Proposed Car Park Extension

Bersham Hall, Bersham Road, Wrexham

Our reference: LB/230585/TN01 – Rev06

Date: 09 August 2024

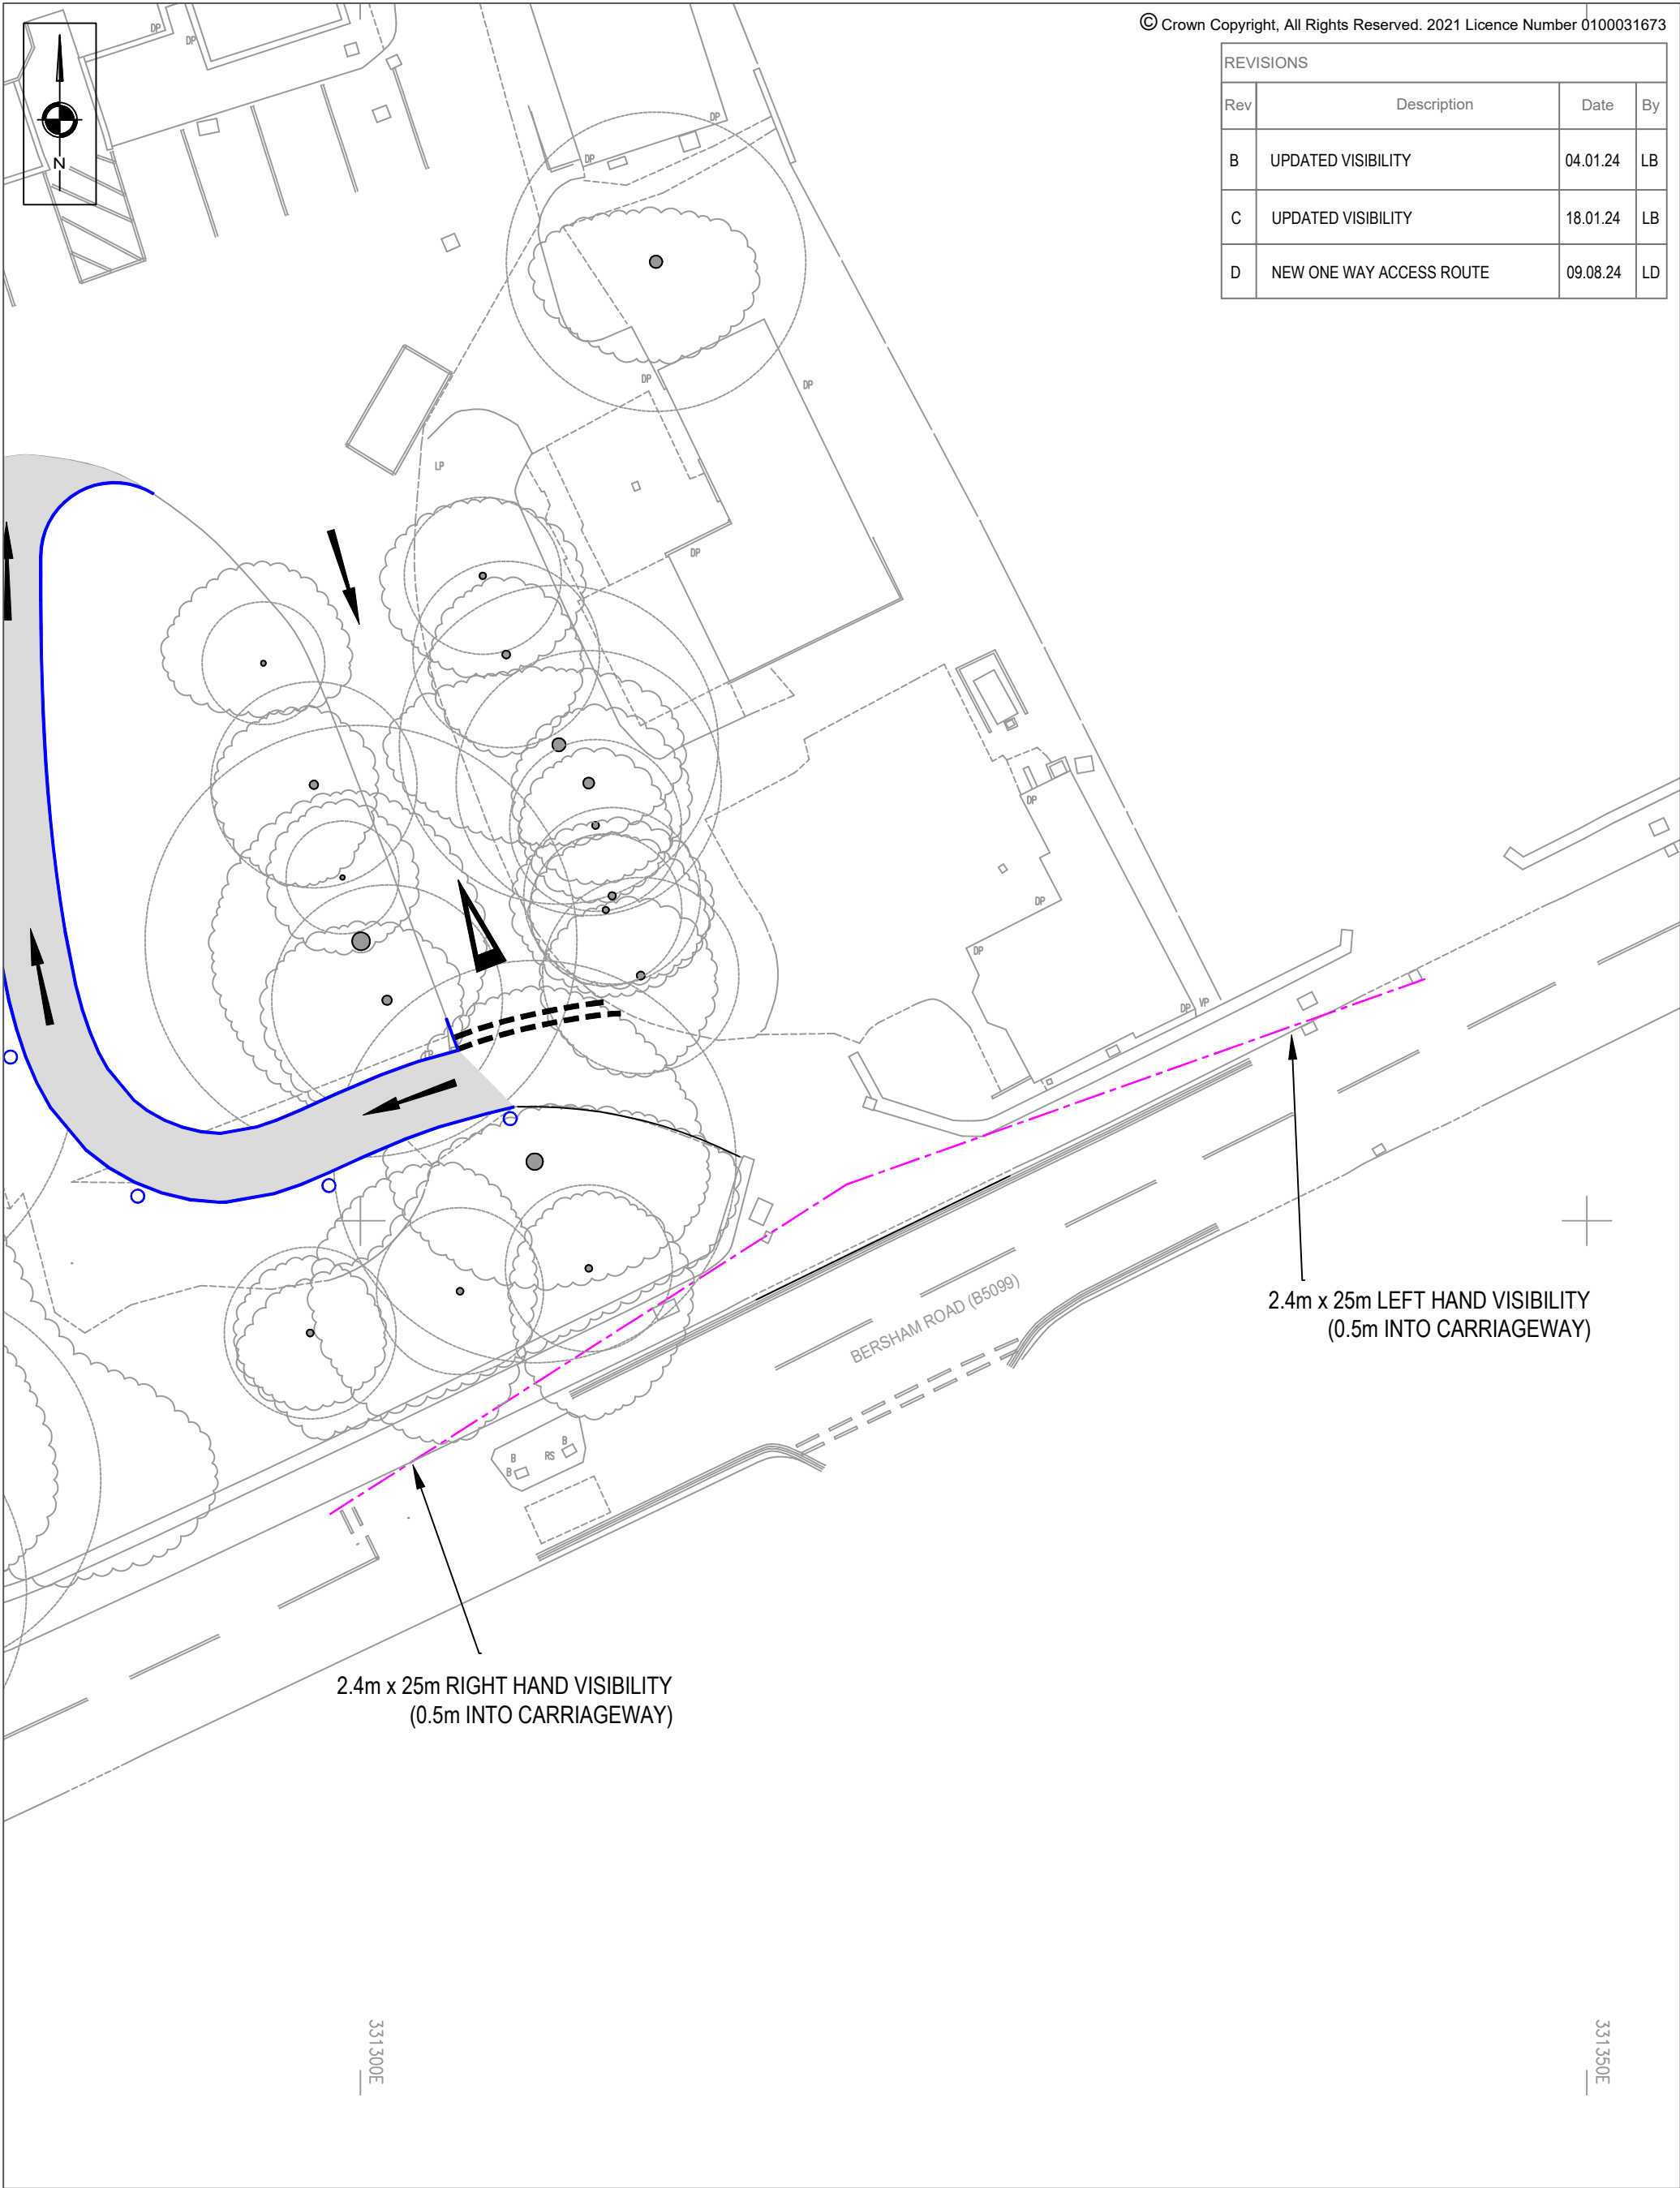
Visibility from the existing access is adequate in the westerly direction providing a splay in excess of 2.4 x 33m measured to the centerline of the adjoining highway. However, visibility in the easterly direction is inadequate providing a splay of approximately 2.4 x 27m measured to the nearside edge of the adjoining highway. Visibility is impeded in this direction by the existing boundary wall.

I would recommend that the applicant indicates the existing / proposed visibility splays on a suitably scaled layout plan.

Based on speeds of 20mph, any proposed / existing access in this location would require visibility splays of 2.4 x 25m in both directions measured to the centerline of the adjoining highway in the westerly direction (due to build out) and to the nearside edge of the adjoining highway in the easterly direction. Visibility from the existing access is adequate providing splays in excess of the above requirements.

- Further to the recent announcement from Welsh Government, the speed limit of Bersham Road has been reduced to 20mph. As shown on drawing SCP/230585/F01 provided in **Appendix E**, the access provides visibility splays of 2.4m x 25m in both directions (drawn 0.5m out into the carriageway due to the nearby chicanes which are also likely to reduce the speed of cars at this location further). All vehicles approaching will therefore be fully visible by vehicles emerging from the access;

SCP/230585/ATR01

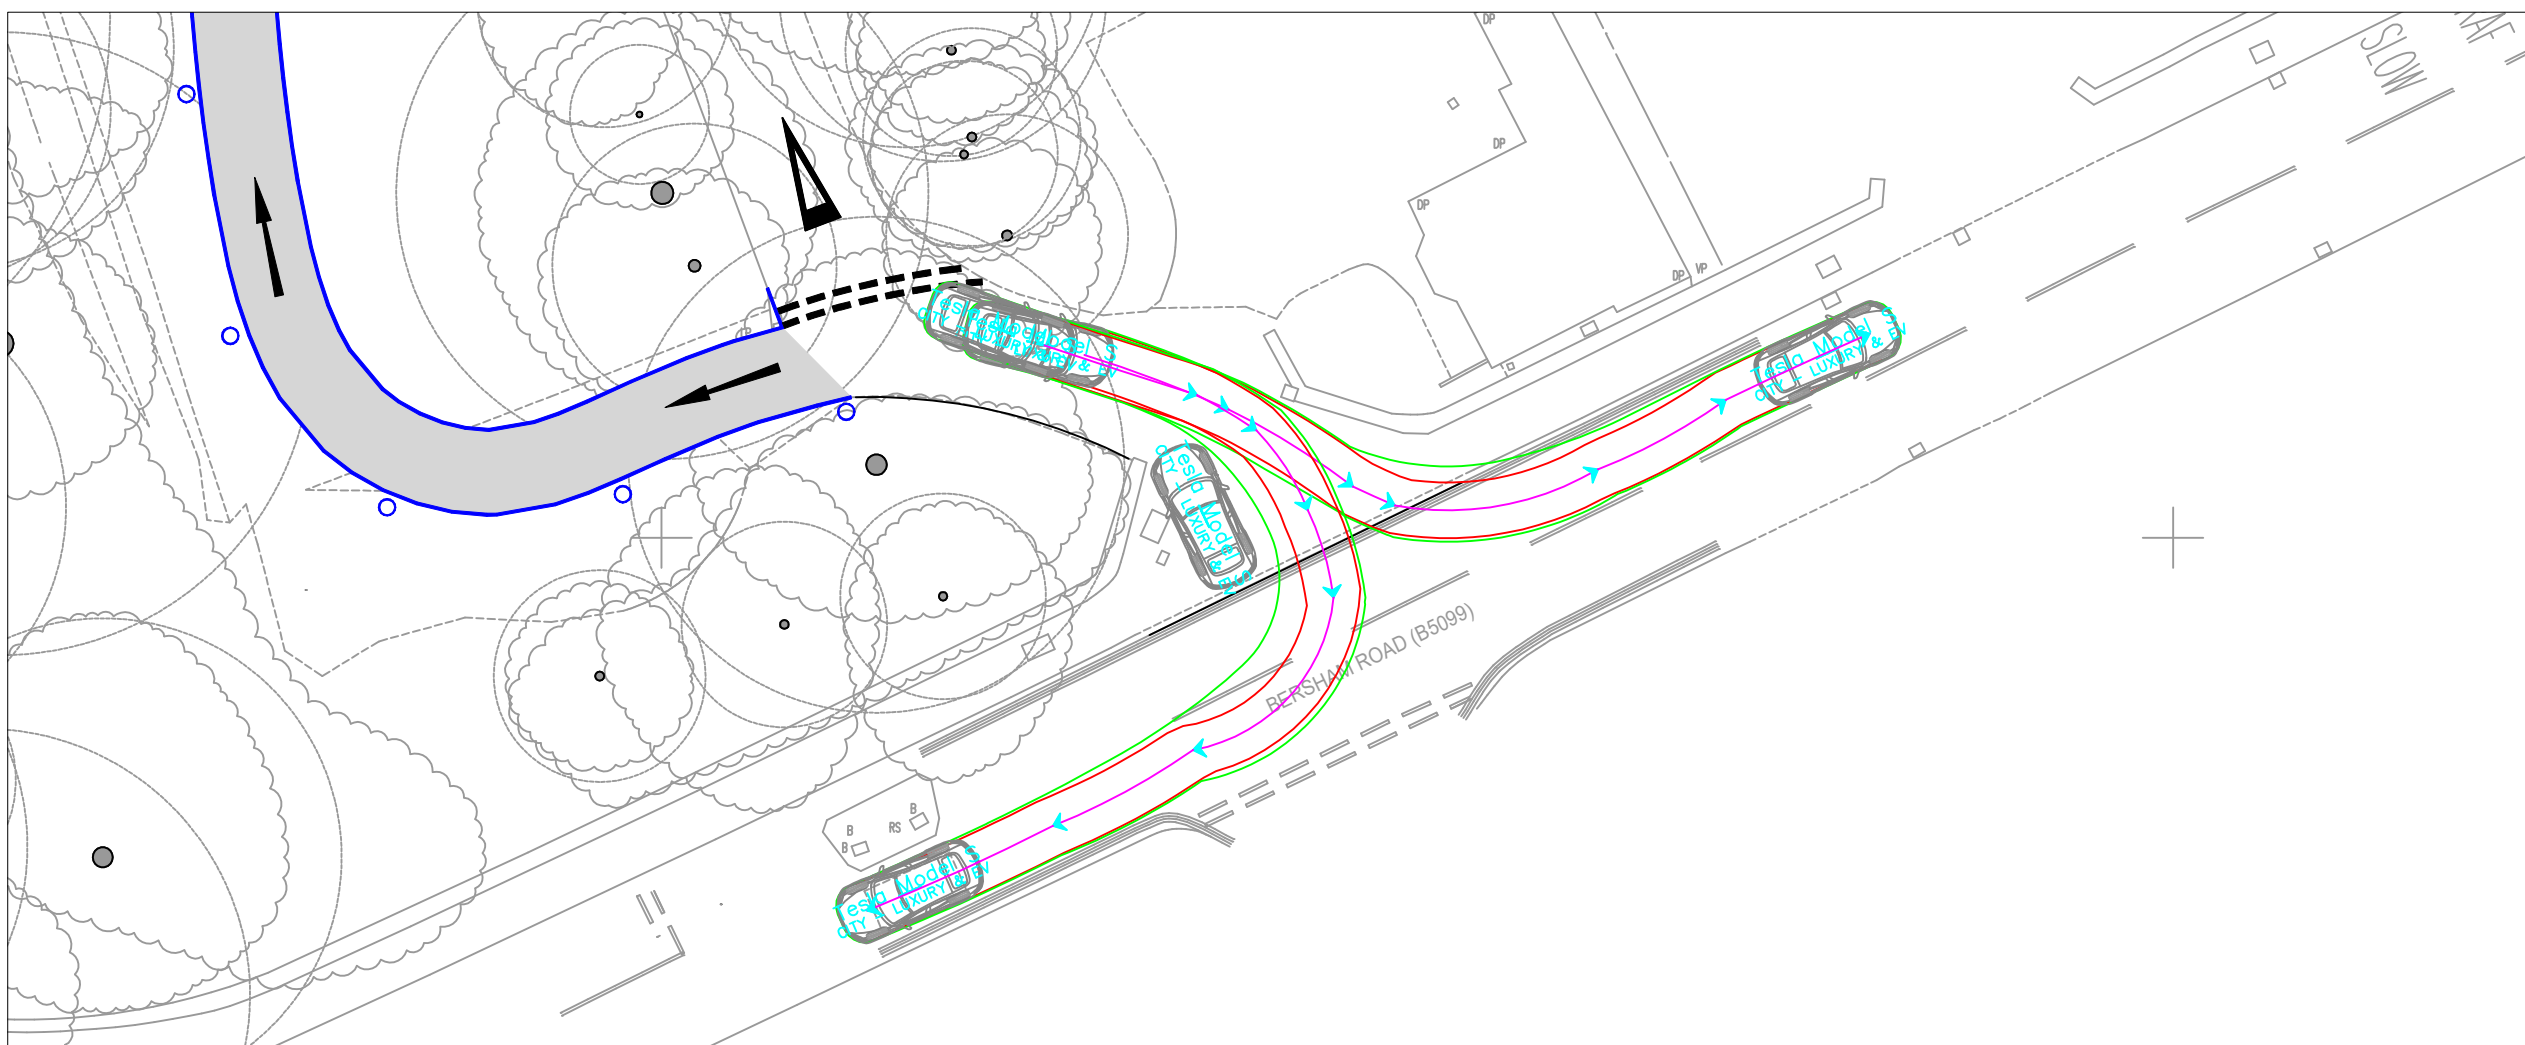
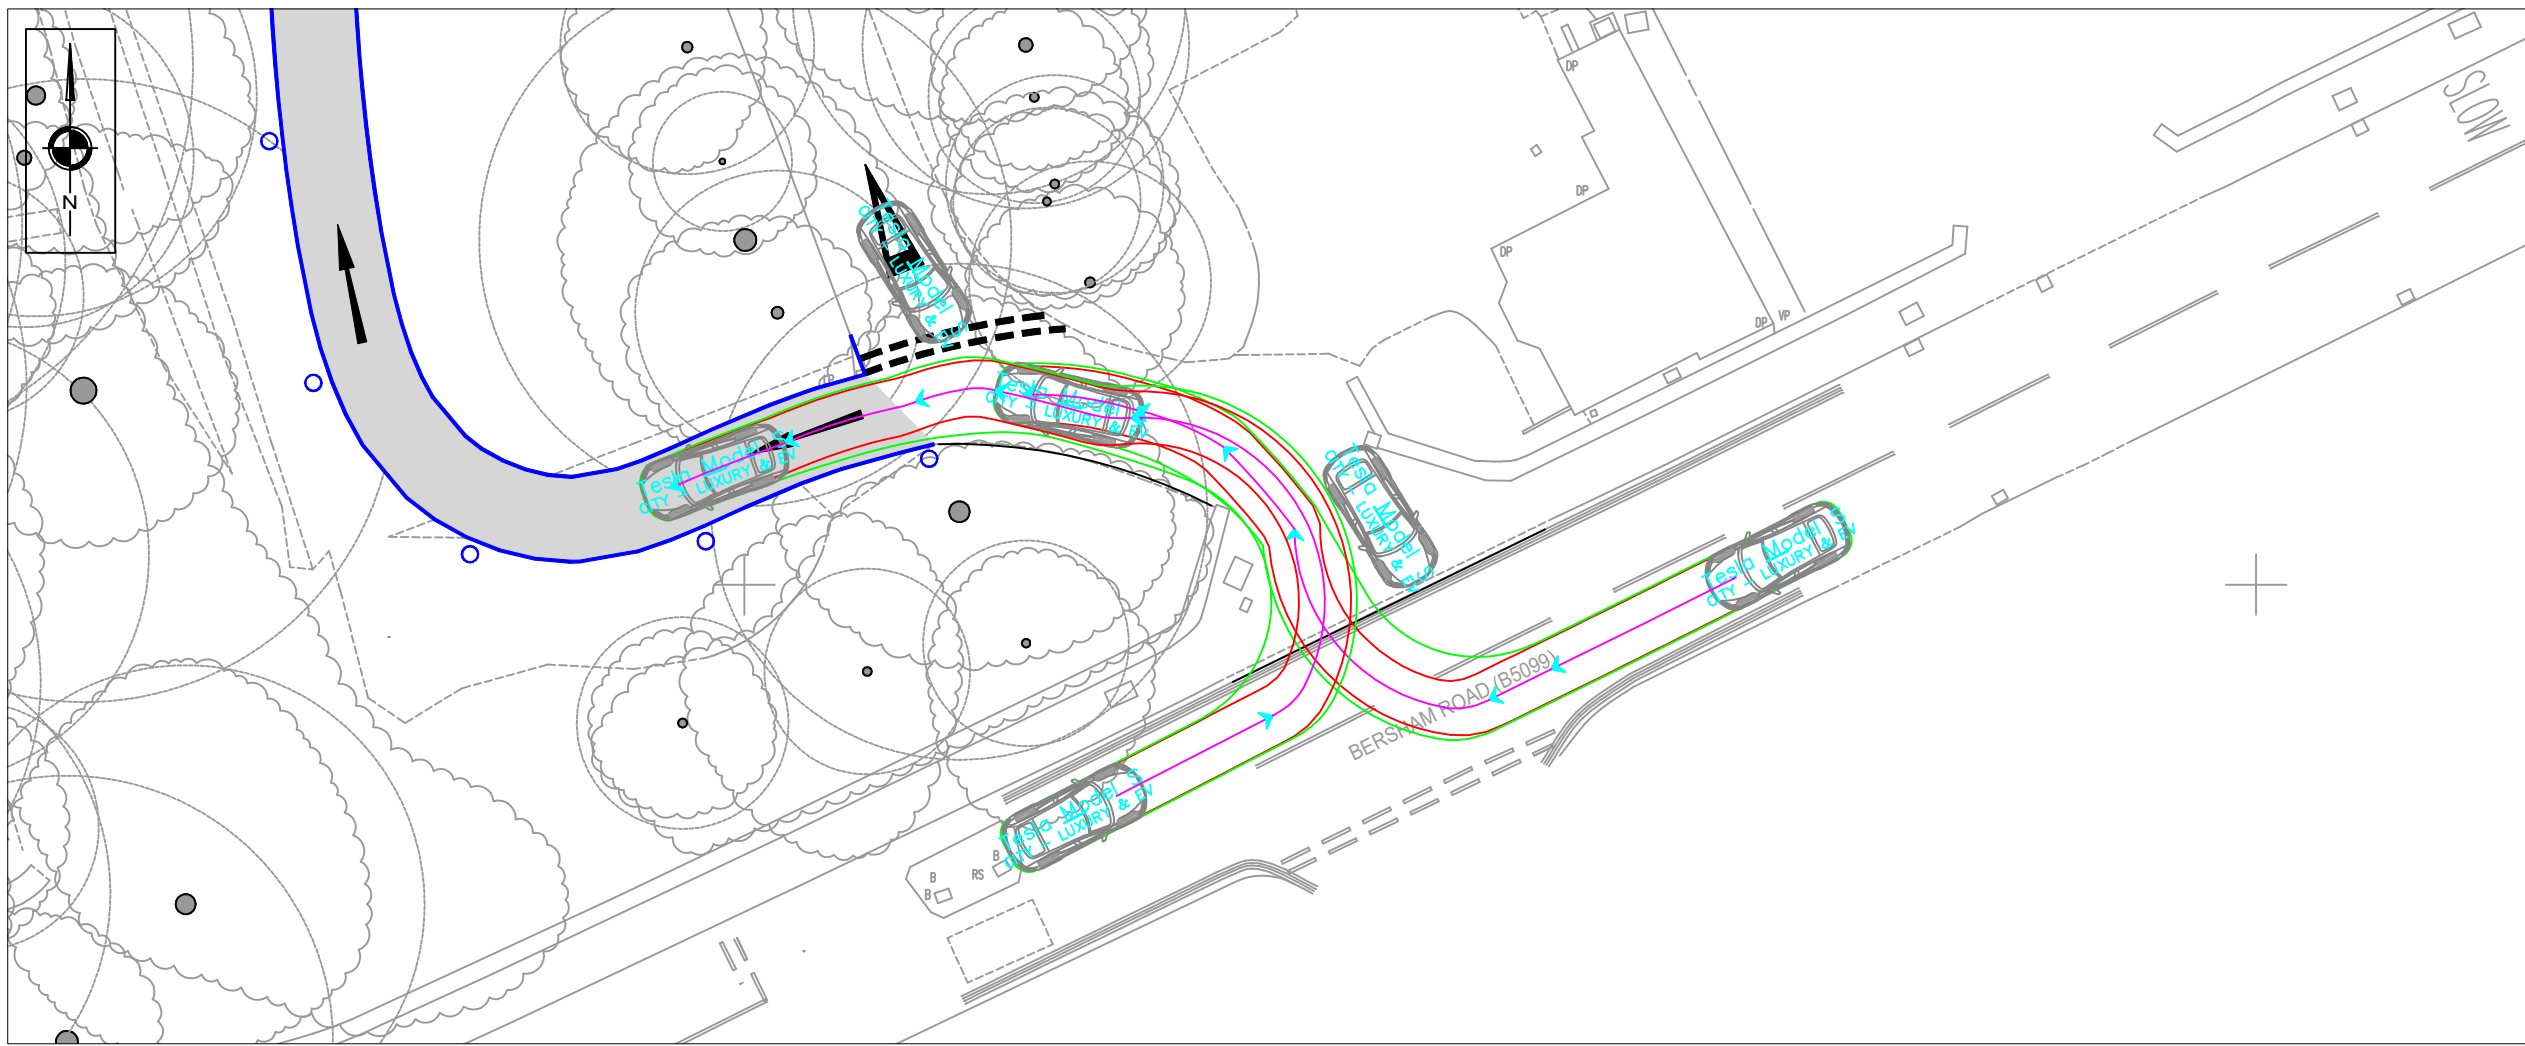
Beyond the gates, the access road reduces in width to around 3.9m which cannot accommodate 2 cars passing simultaneously. I understand that the applicant is willing to widen this restricted section to improve access. I would recommend that the applicant provides swept path details of 2 standard size cars accessing / exiting the main entrance simultaneously. **I would recommend that the applicant indicates the proposed access improvements along with appropriate swept path details on a suitably scaled layout plan.**

- Two cars can pass each other at the bellmouth of the existing junction access, as shown on drawing SCP/230585/ATR01 provided in **Appendix F**;
- The proposals will increase on-site parking and remove existing on-road parking which occurs along Bersham Road. The proposals will therefore provide highway safety benefits along the surrounding highway network;
